Field Modification FM22006

VS2.5 (2 PS): Replacing UG69* and NAPS53 with UG132 and NAPS58A

Issue 1.0 01 November 2022

FIELD MODIFICATION

Figure 1: VS2.5 Top View with NAPS53 and UG69*

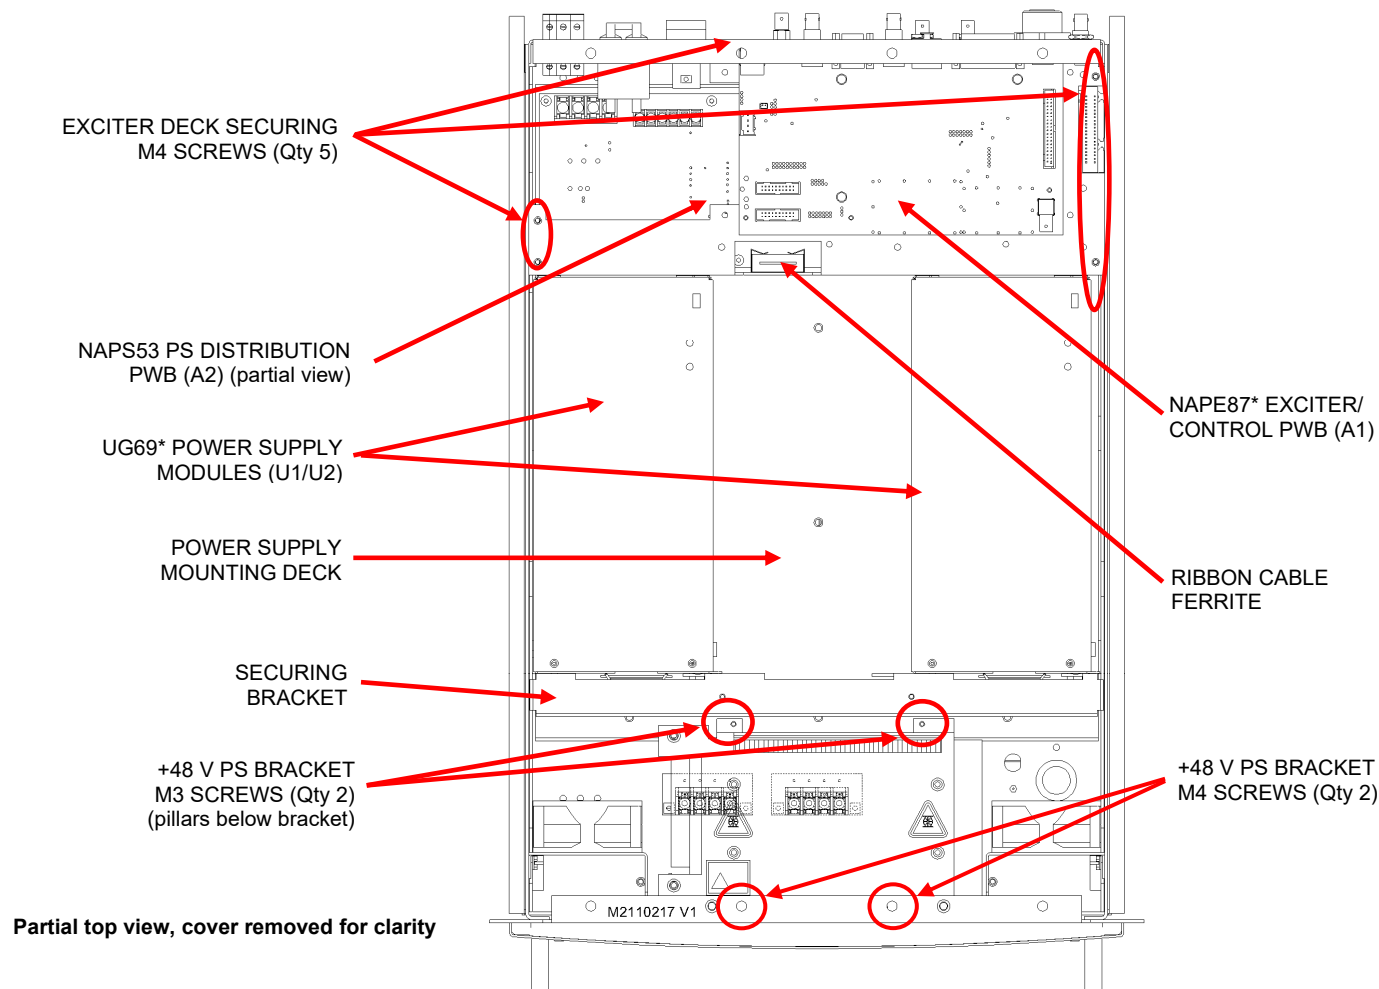
- (a) Remove the VS2.5's top cover and retain hardware.
- (b) Remove the securing bracket from the front of the Power Supply Modules (U1 and U2) by removing the two (2) M3 screws in the top of the bracket (see Figure 1) and the two (2) M4 countersunk screws in each side of the transmitter chassis. Discard bracket and retain hardware.
- (c) Slide the Power Supply Modules toward the front of the transmitter to disengage them from their mating connectors.
- (d) Remove the Power Supply Modules from the transmitter. If desired, retain any functional Power Supply Modules as spares for other transmitters that use UG69* modules. Discard defective Power Supply Modules as per local electronics waste management policies (if applicable).

- (f) Remove and retain the five M4 screws that secure the Exciter Deck (see Figure 1).
- (g) Before removing the Exciter Deck, ensure that the exciter wiring and associated items are clear of the Power Supply Distribution PWB and Exciter Deck, cutting tyrap if necessary. Cut the tyrap around the Ribbon Cable Ferrite (see Figure 1) to move the ribbon cables clear of the Exciter Deck and be careful in the following step not to damage the ferrite. Cut the adhesive tape that secures the Ribbon Cable Ferrite bracket to the Exciter Deck. Retain the adhesive tape for re-installation.

- (e) Remove the countersunk M3 screws (nine for NARF66I* transmitters; 12 for NARF66H* and older transmitters) that secure the Power Supply Mounting Deck to the transmitter chassis (see Figure 1 to locate the Power Supply Mounting Deck and see Figure 3 for securing hardware location). Retain hardware for re-installation.

- (f) See Figure 1. Remove and retain the two M3 screws securing the +48 V Power Supply Mounting Bracket to the Power Supply Mounting Deck. Remove and retain the two countersunk M4 screws securing the +48 V Power Mounting Bracket, from just above the front panel, and carefully reposition the +48V PS Mounting Bracket to allow access to the two (2) pillars under the M3 screws. Take care to ensure the +48 V Power Supply's wiring is not damaged.

Figure 2: Orientation of Installed Items – Exploded View

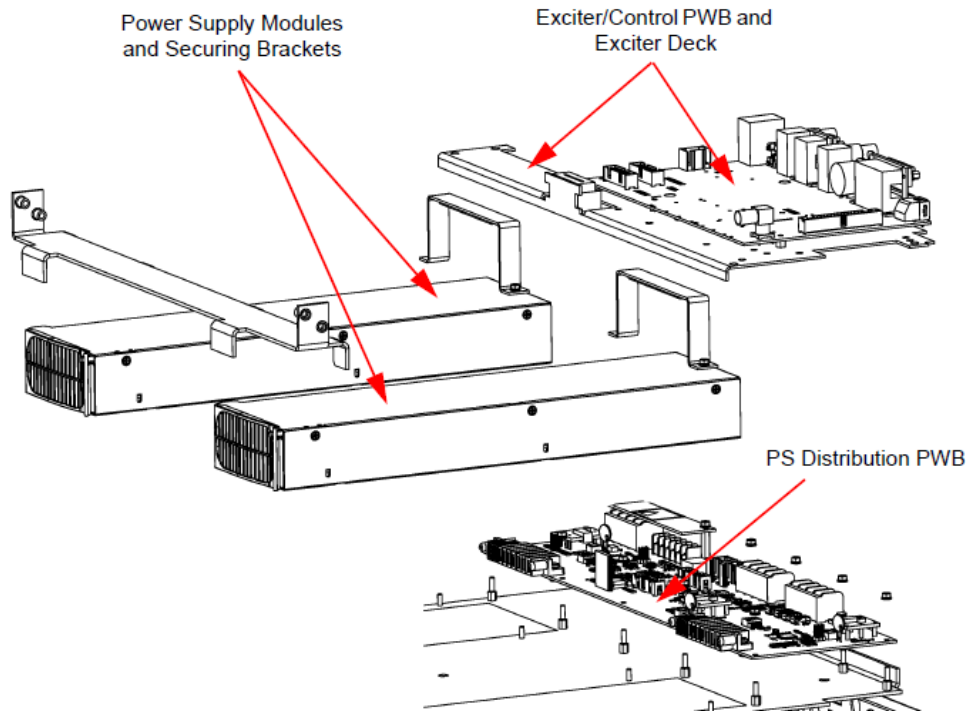
Refer to Figures 2, 3 and the attached Mechanical Drawing MD-4 for reference.

- (d) Install the Power Supply Distribution PWB on its 11 mounting pillars (see Figures 2 and 3). Use hardware retained in step 2.2 (d) to secure the PWB (not all hardware is reused), using a 5.5-mm nut driver for nine M3 nuts, split and flat washers, and a 6-mm nut driver for two pillars near TB1 and TB2.

Figure 3: New Power Supply Mounting Deck

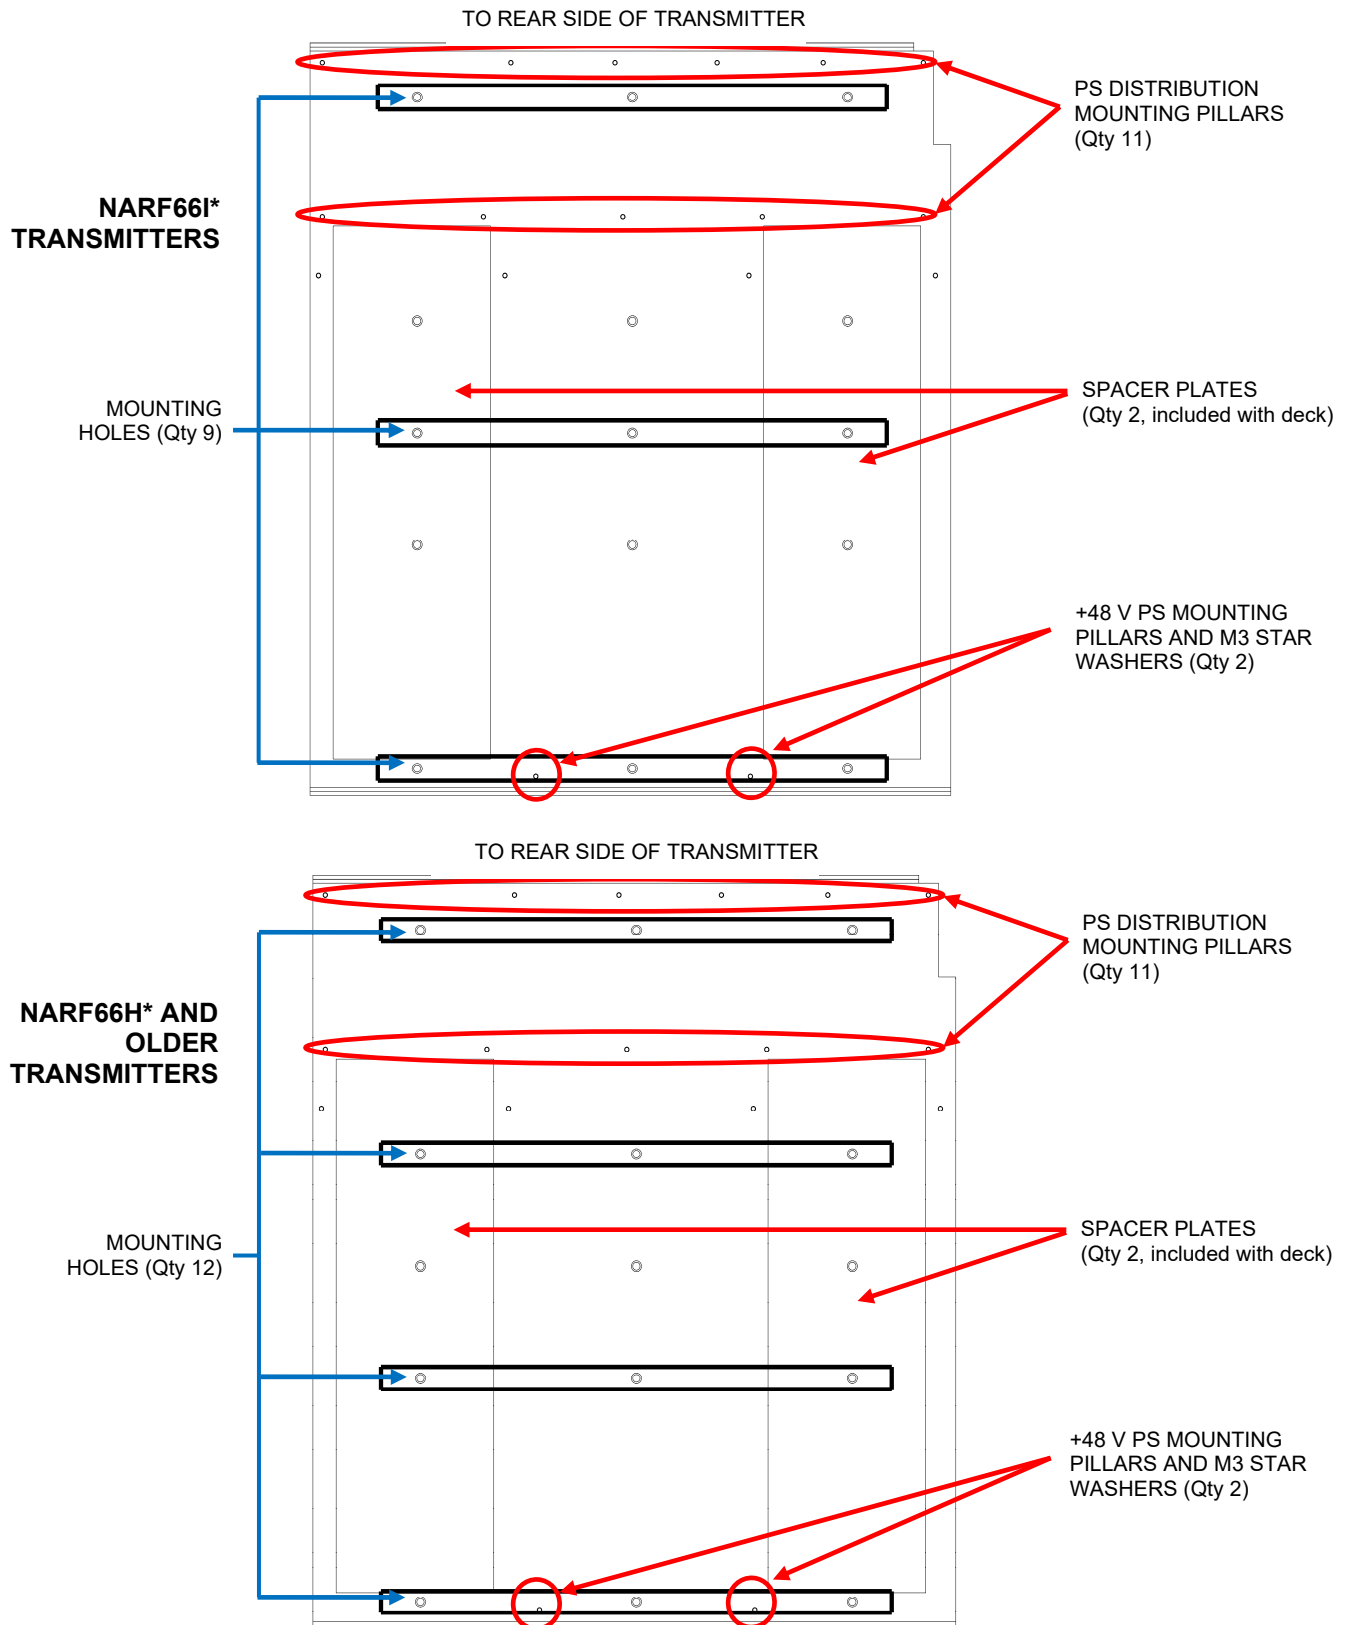
- (b) Install 11 of the 12 pillars and washers retained in step 2.2 (h) in the PS Distribution Mounting Pillars positions shown in Figure 3. Install the chafe rail on the rear side edge.

- (c) While ensuring that all wires removed in step 2.2 (c) are clear of the deck area, install the Power Supply Mounting Deck to the transmitter chassis using the M3 countersunk screws (nine for NARF66I* transmitters; 12 for NARF66H* and older transmitters) retained in step 2.2 (e). See Figure 3 for mounting locations for both scenarios.

- (f) Connect the 17 wires (# 7 through 14 and 25 through 33) removed in step 2.2 (b) to terminal blocks TB1 through TB4 of the Power Supply Distribution PWB. Refer to Table 4.3, Wiring List – VS2.5 Transmitter of the Troubleshooting Manual for wiring details.
- Torque connections on TB1, TB3 and TB4 to 20 in-lbs (2.24 N-m).
 - Torque connections on TB2 to 6 in-lbs (0.67 N-m).
- (g) Re-install the cover over TB1 and TB2 using retained M3 screws.
- (h) Use a 6-mm nut driver to re-install the pillars retained in step 2.2 (g) on the Power Supply Mounting Deck, on top of new M3 star washers (Nautel Part # HMW10) from the Hardware Kit. See Figure 3 for +48 V Power Supply mounting pillar locations.

Figure 4: VS2.5 Top View with new PS Distribution PWB and Power Supply Modules

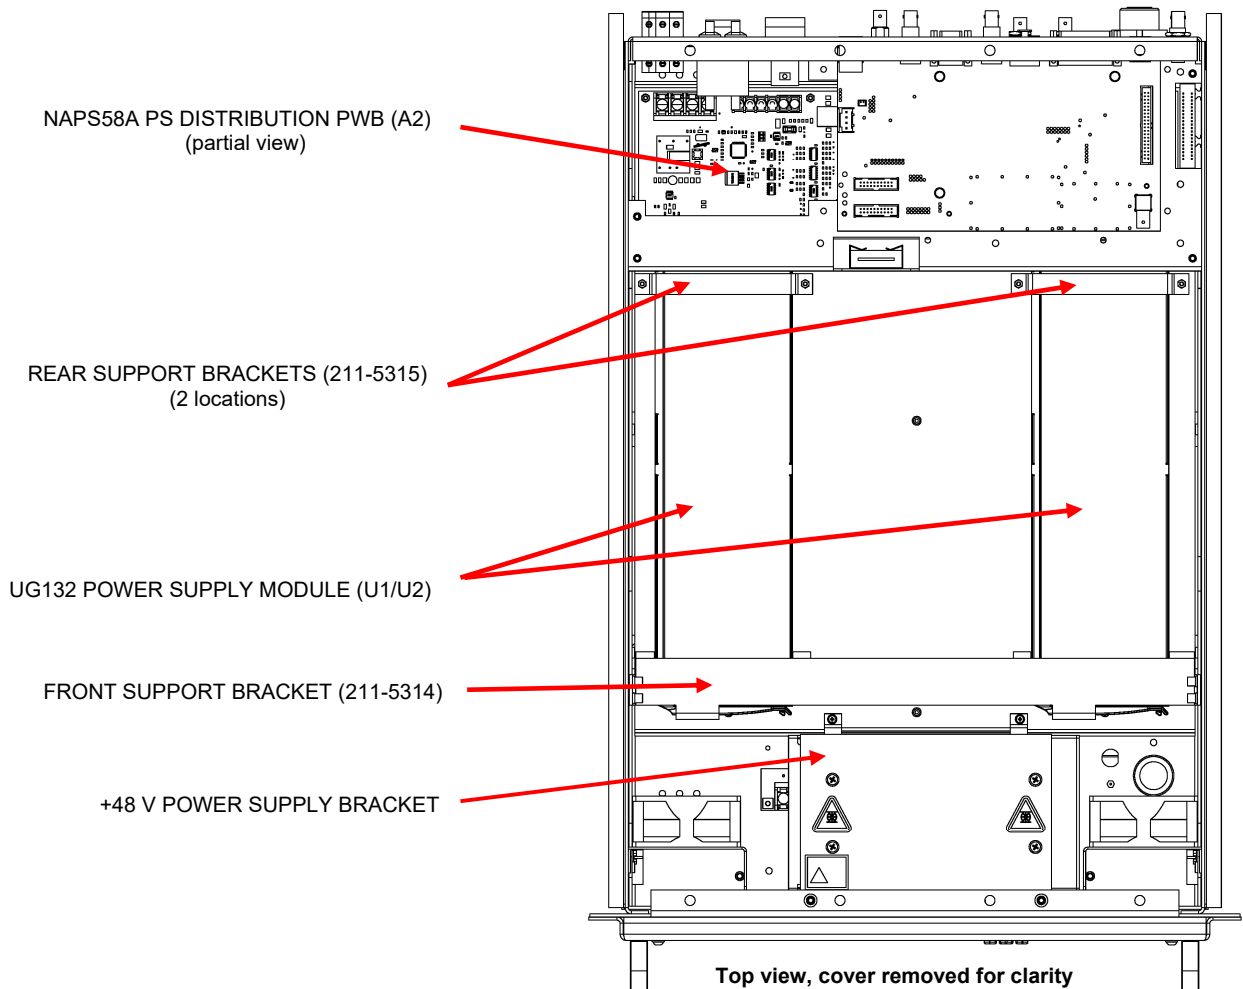
- (b) Install the new Power Supply Modules in the transmitter and slide them toward the rear of the transmitter to engage them with their mating connectors. Note that the Power Supply Modules should be resting on their respective Spacer Plates (see Figure 3) when correctly positioned.
- (c) Install the Front Support Bracket on the front of the Power Supply Modules using the four M4 screws removed in Step 2.1 (b). The bracket is secured with two screws on each side of the transmitter. See Figure 4.
- (d) Install the two (2) Rear Support Brackets on the rear of the Power Supply Modules using the four (4) sets of M3 nuts and washers (Nautel Part #'s HMN02, HMW02 and HMW32), found in the Hardware Kit. See Figure 4.
